Decision Notice
CHANGE TO A DEVELOPMENT APPROVAL
Planning Act 2016 Section 83

Development Approval: Material Change of Use – Impact – Dwelling House
Location: 1F Alderley Street, RANGEVILLE QLD 4350
Property Description: Lot 62 CC555
Relevant Planning Scheme: *Toowoomba Regional Planning Scheme 2012*

APPLICATION NUMBER:	MCUI/2019/3145/A
APPLICANT:	Excavation Equipment Pty Ltd
LOCATION:	1F Alderley Street, RANGEVILLE QLD 4350
PROPERTY DESCRIPTION:	Lot 62 CC555
APPROVED USE:	Dwelling House
ZONING:	Limited Development (Constrained Land) Zone

Approval: Material Change of Use for Dwelling
Location: 1F Alderley Street Rangeville
Property Description: Lot 62 CC555

FLOOR PLAN - UPPER
1 : 100

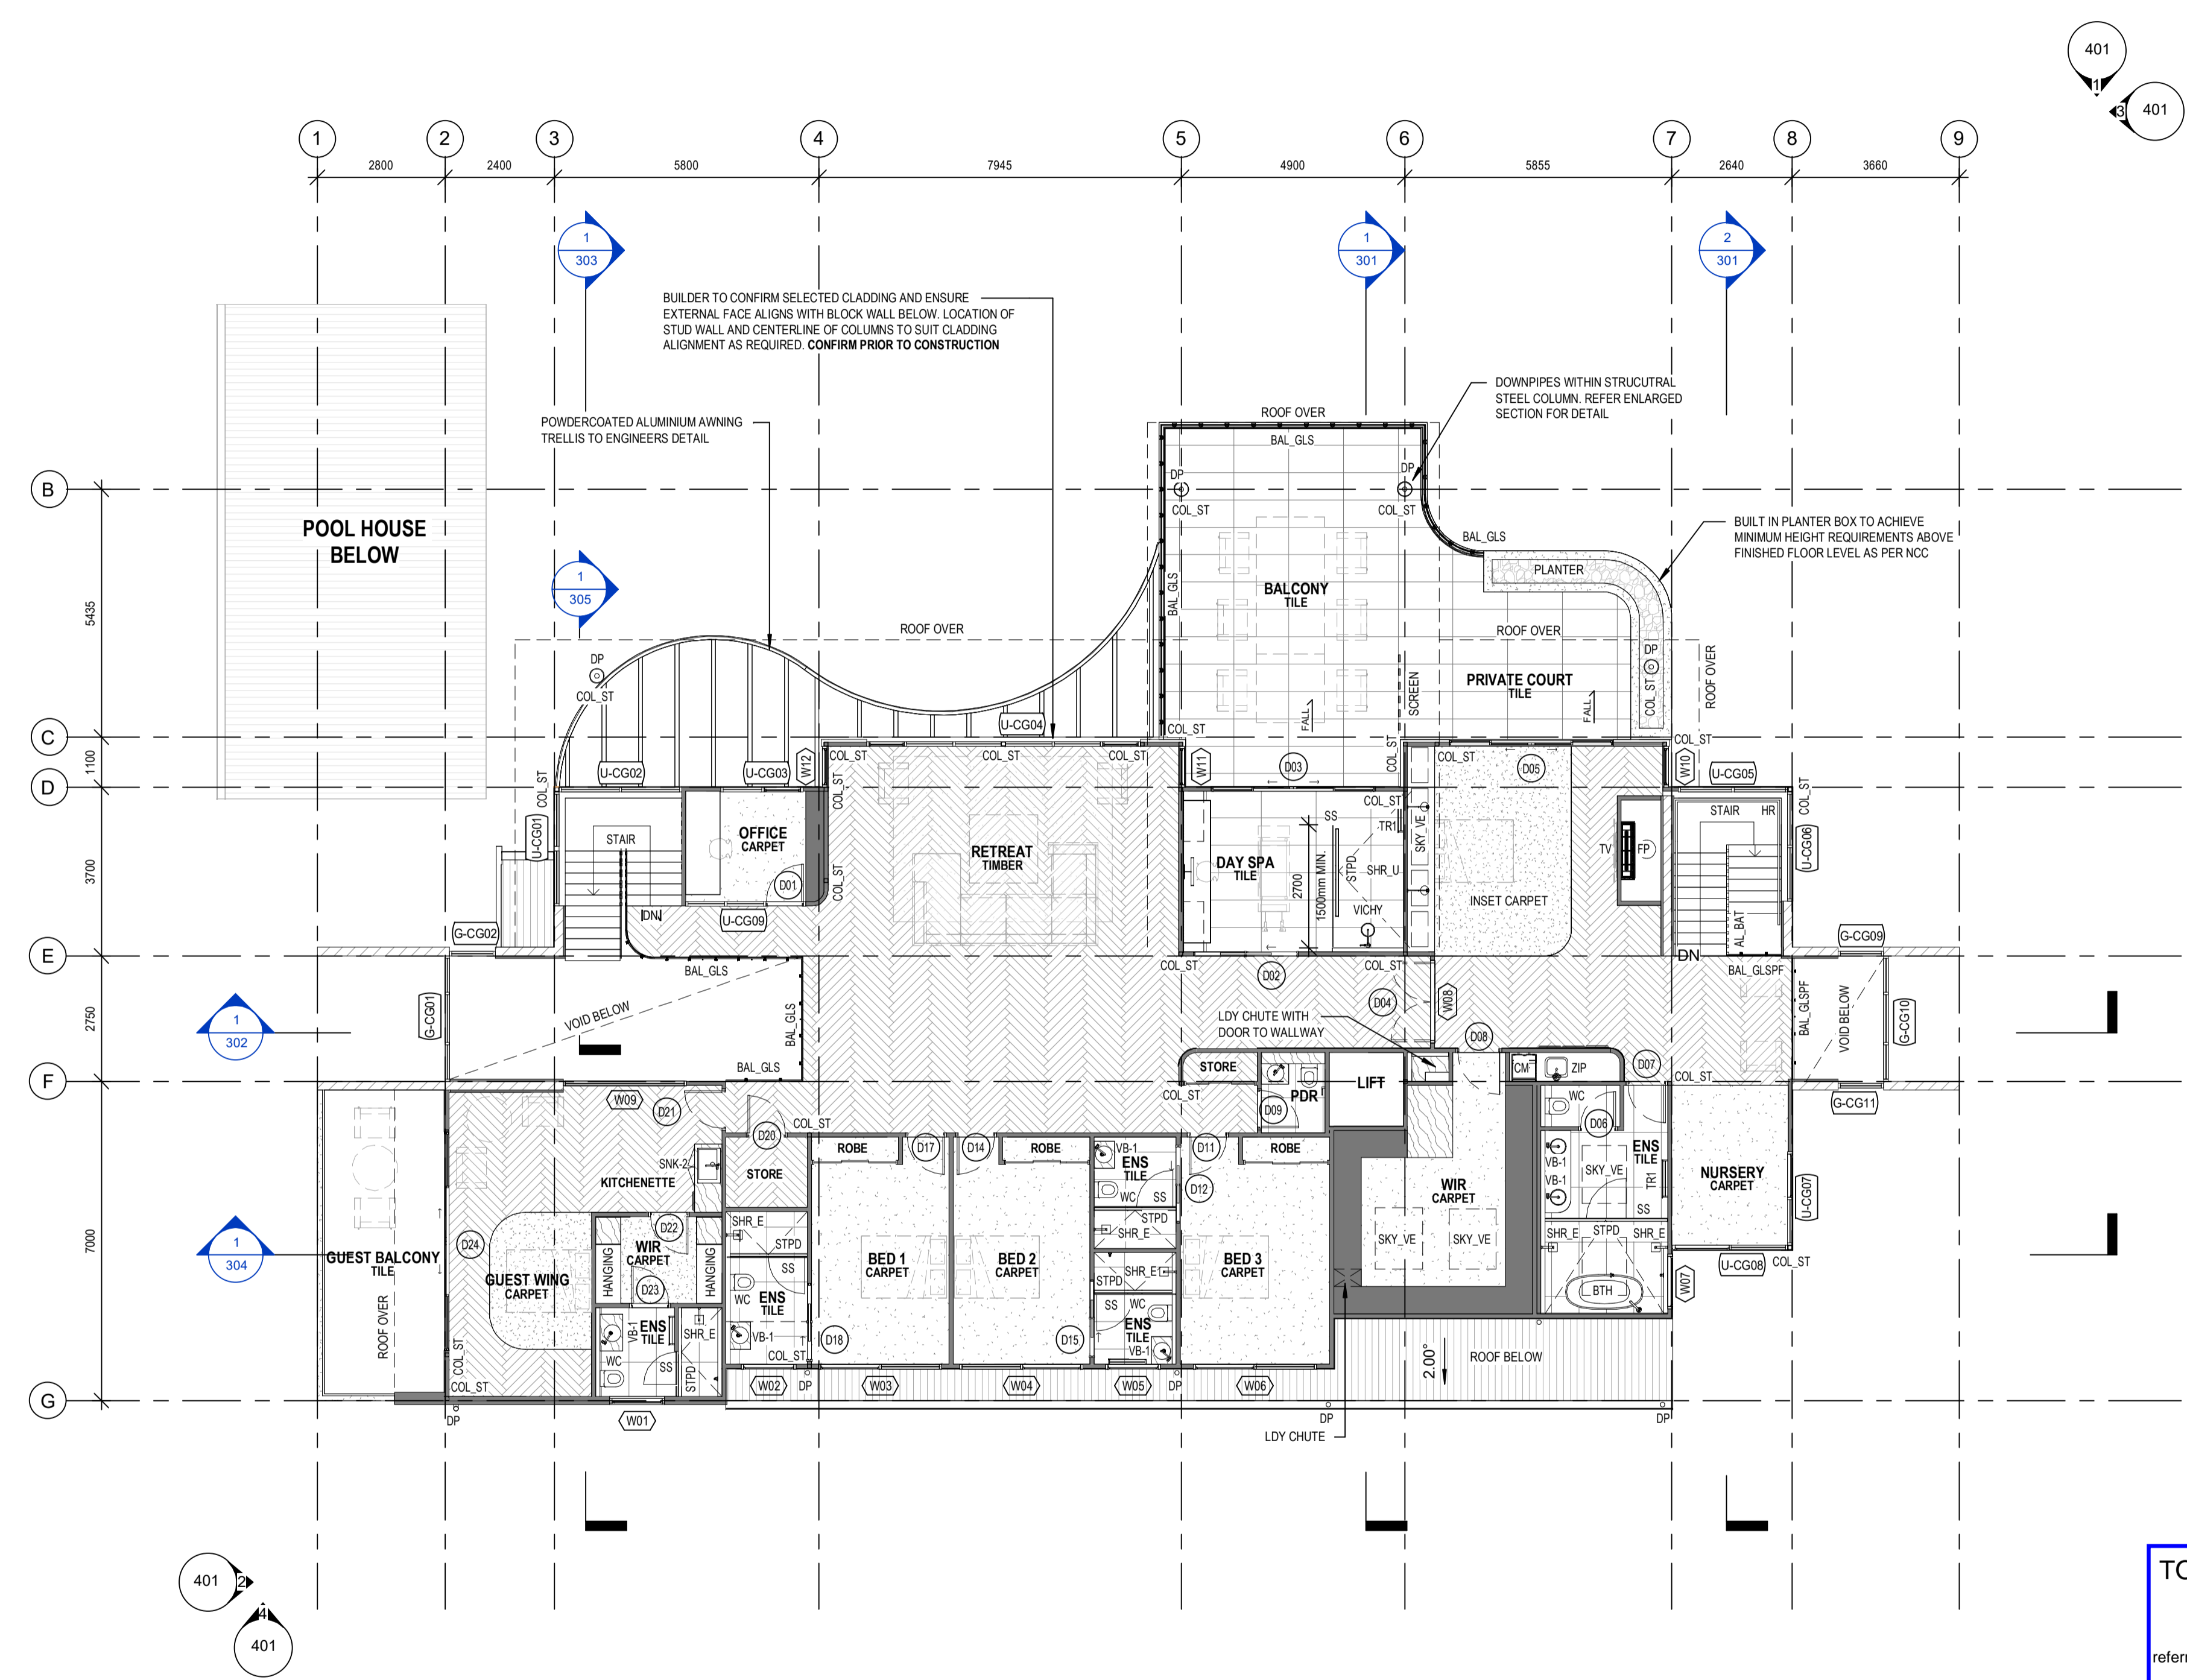
Plan No: 1319.24047, Issue 6
Description: Upper Floor Plan, prepared by VHD Studio and dated 17 December 2024
Amendments: Nil

1 NORTH EAST
102 1: 100

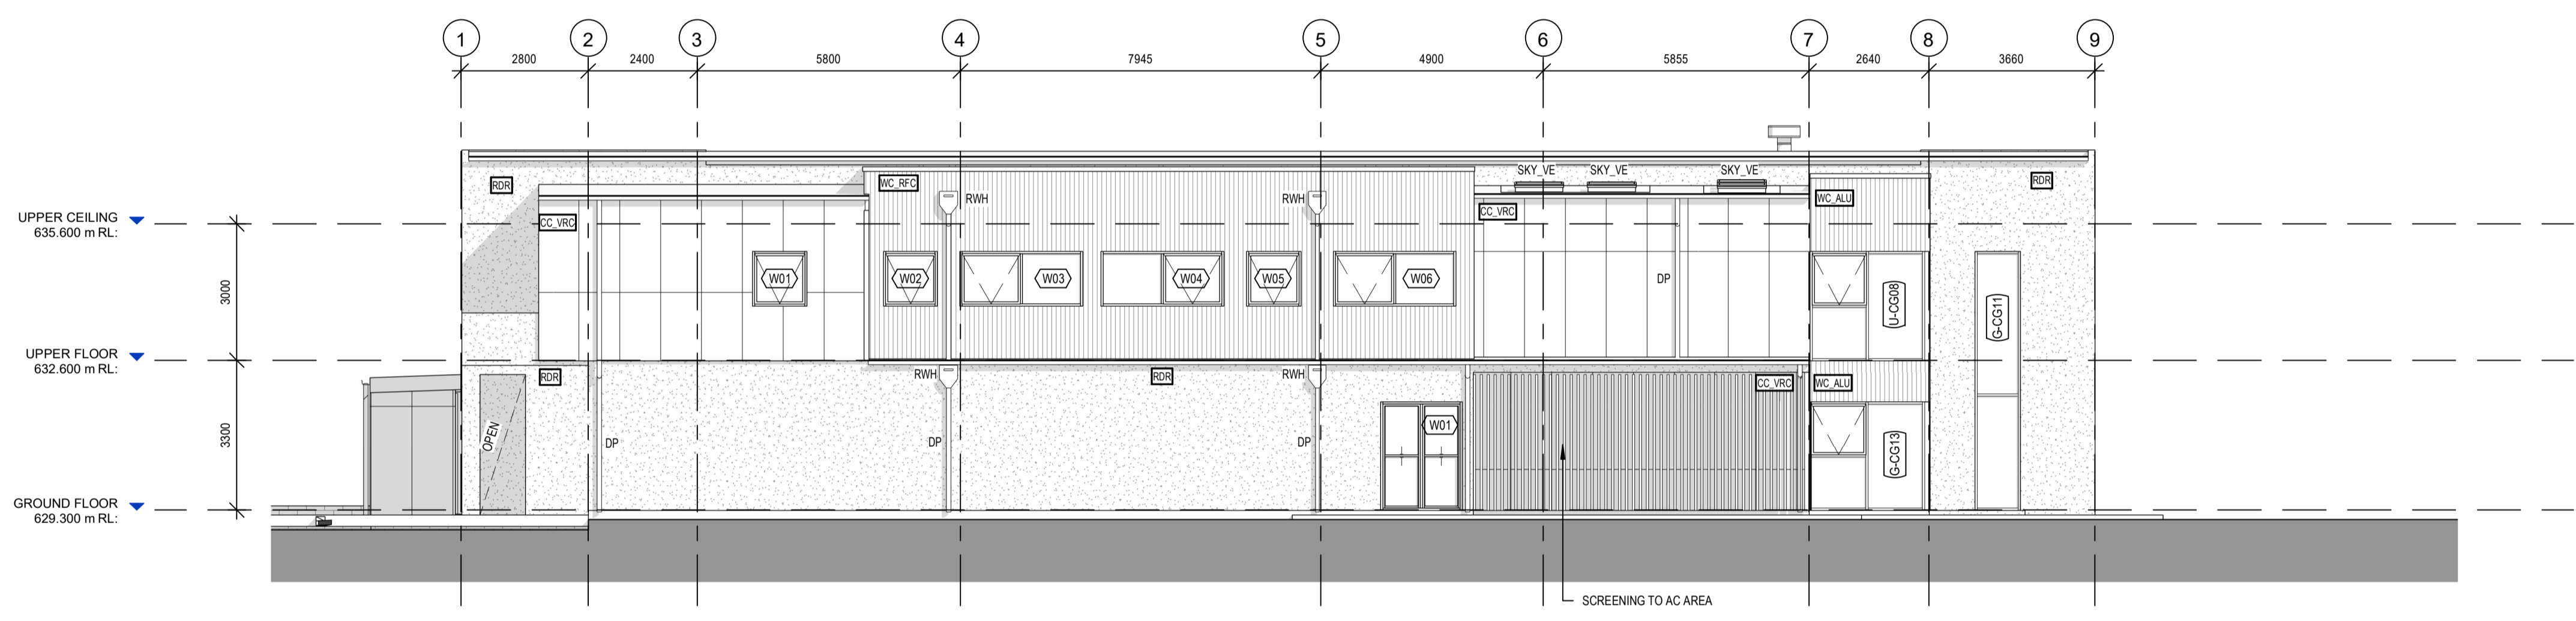
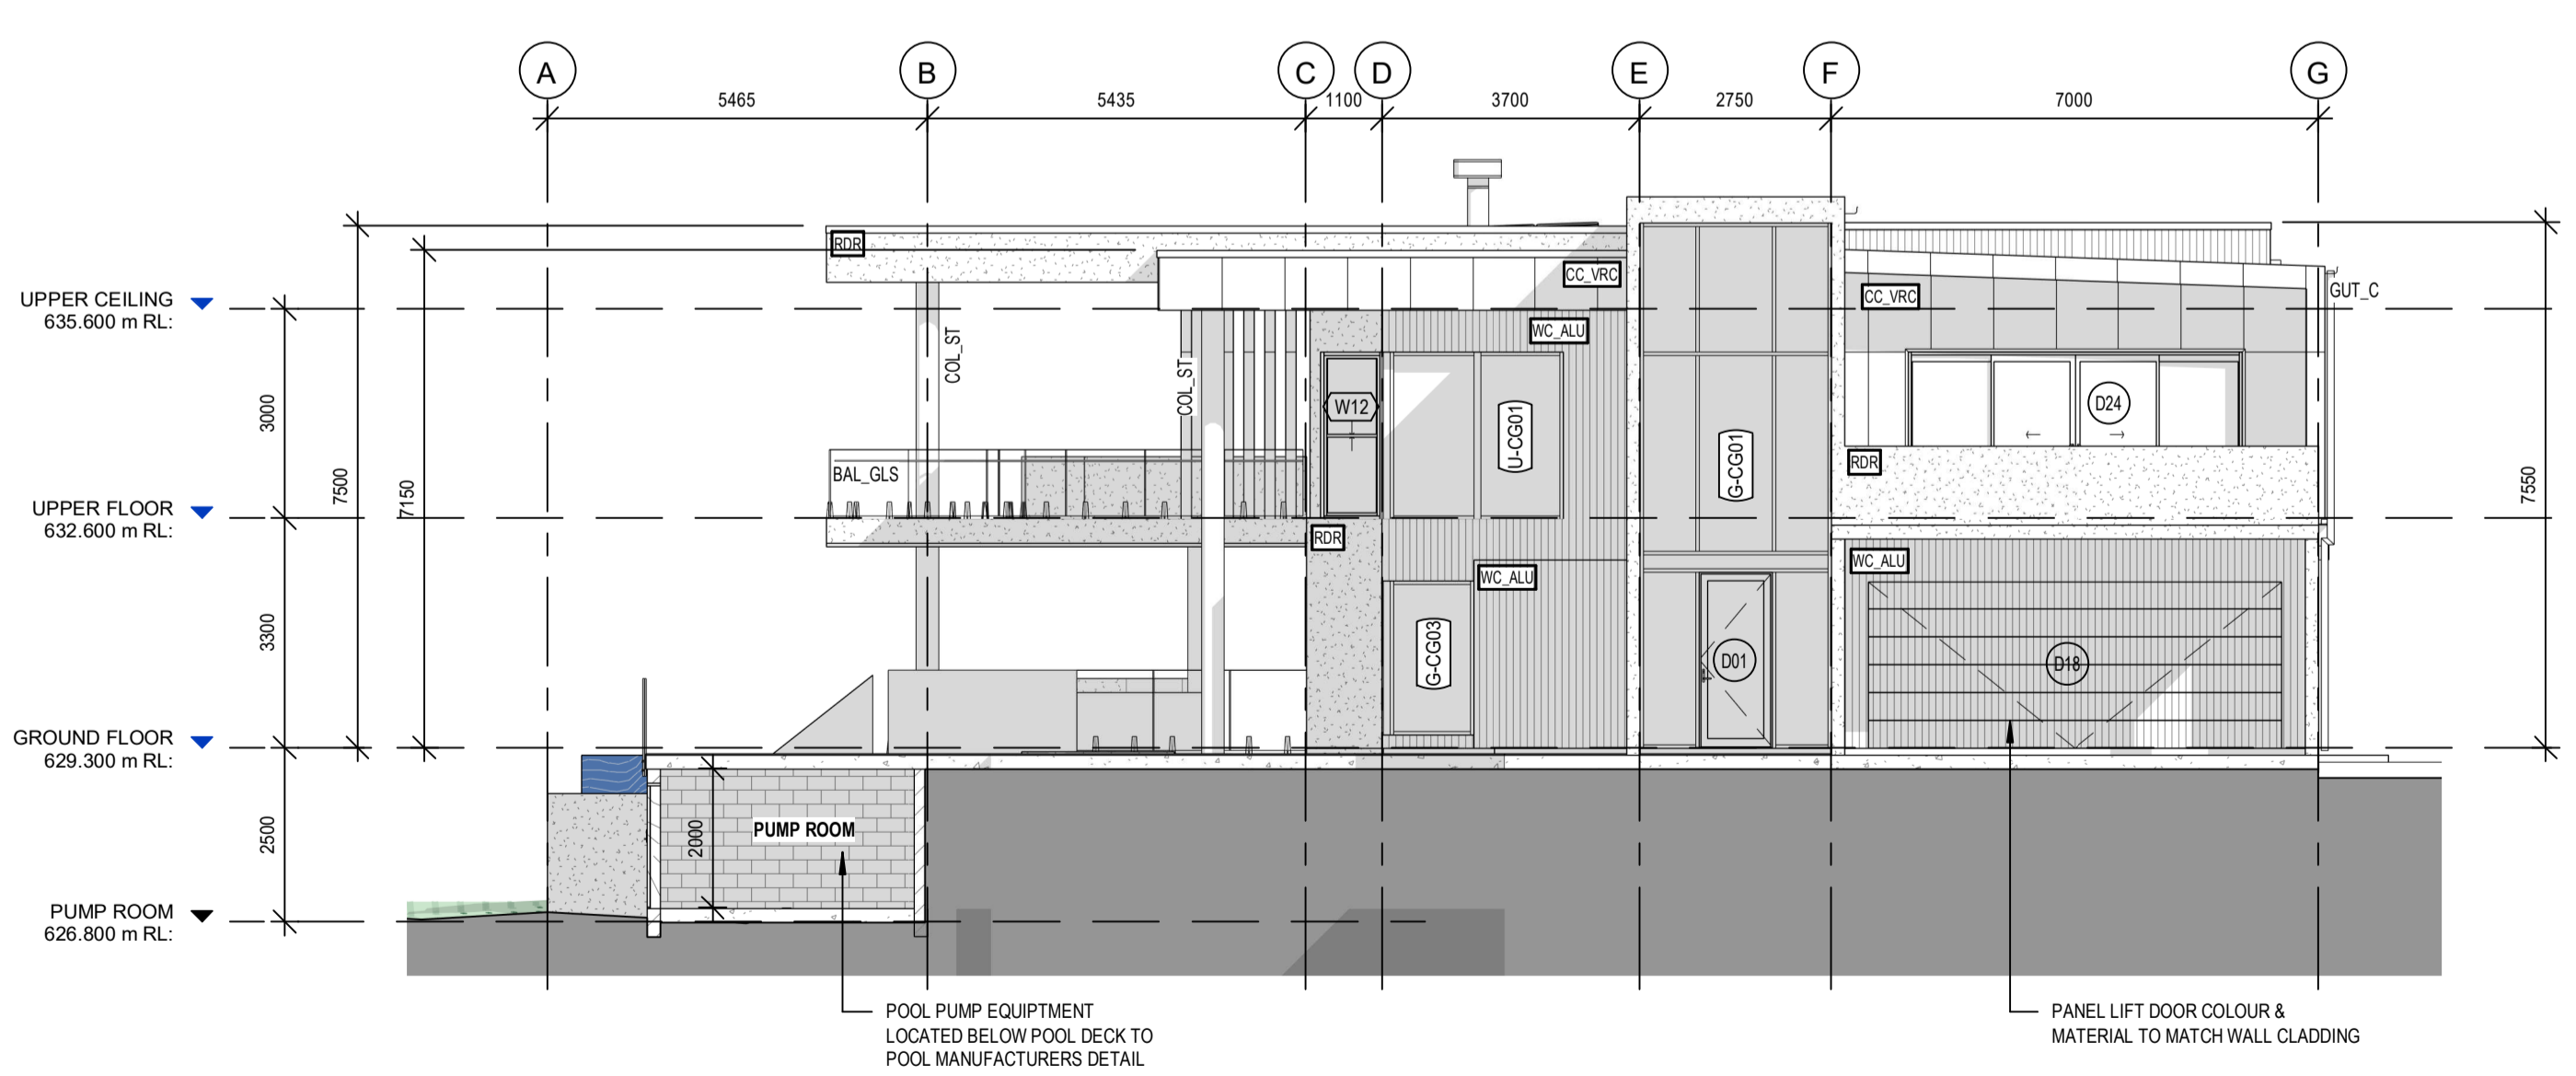
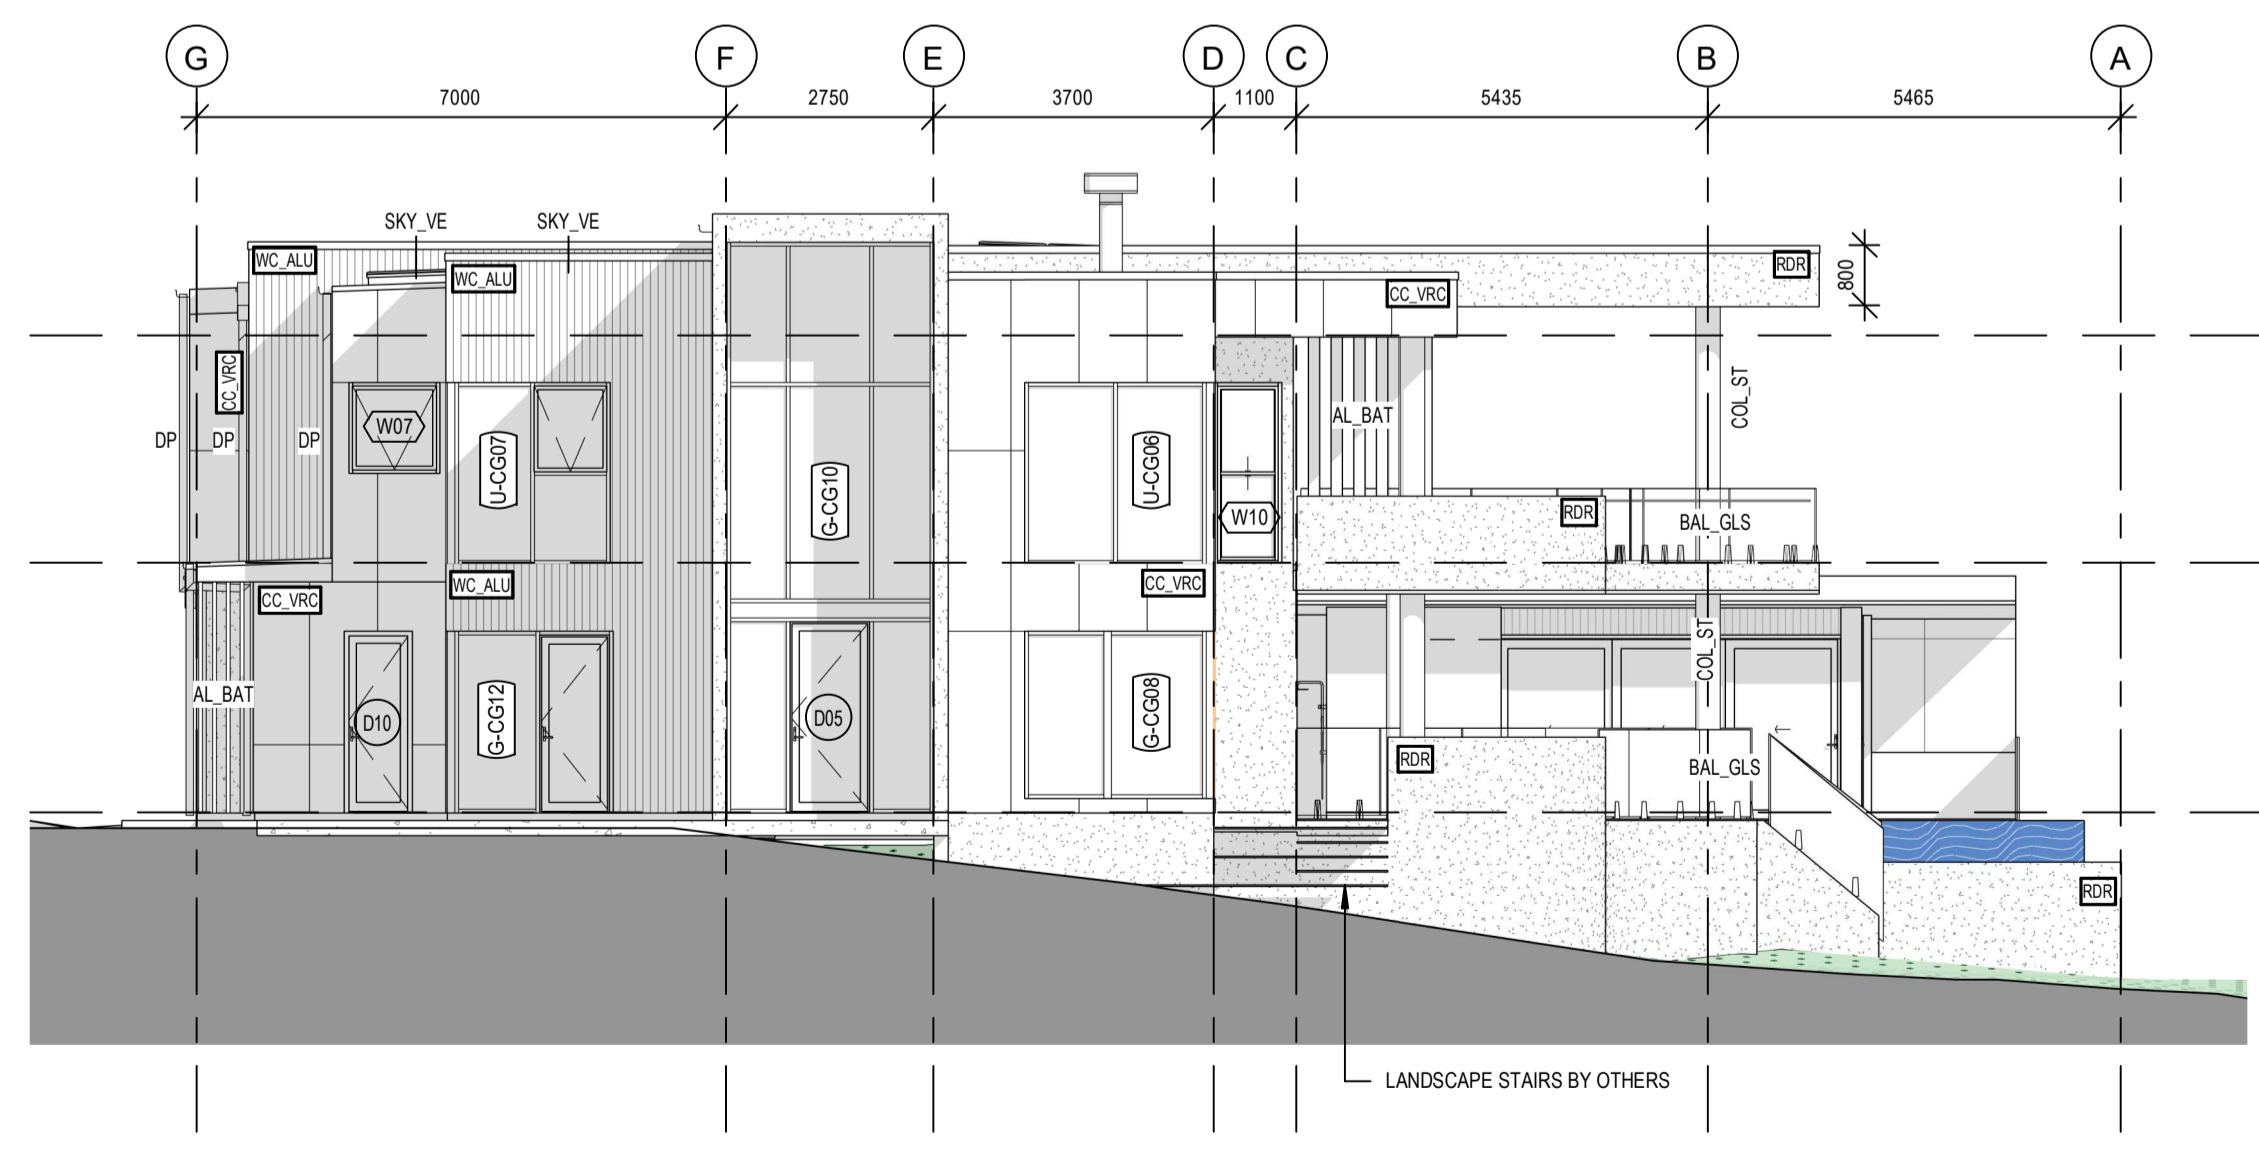
Plan No: 1319.24047, Issue 6
Description: Building Elevations, prepared by VHD Studio and dated 17 December 2024
Amendments: Nil
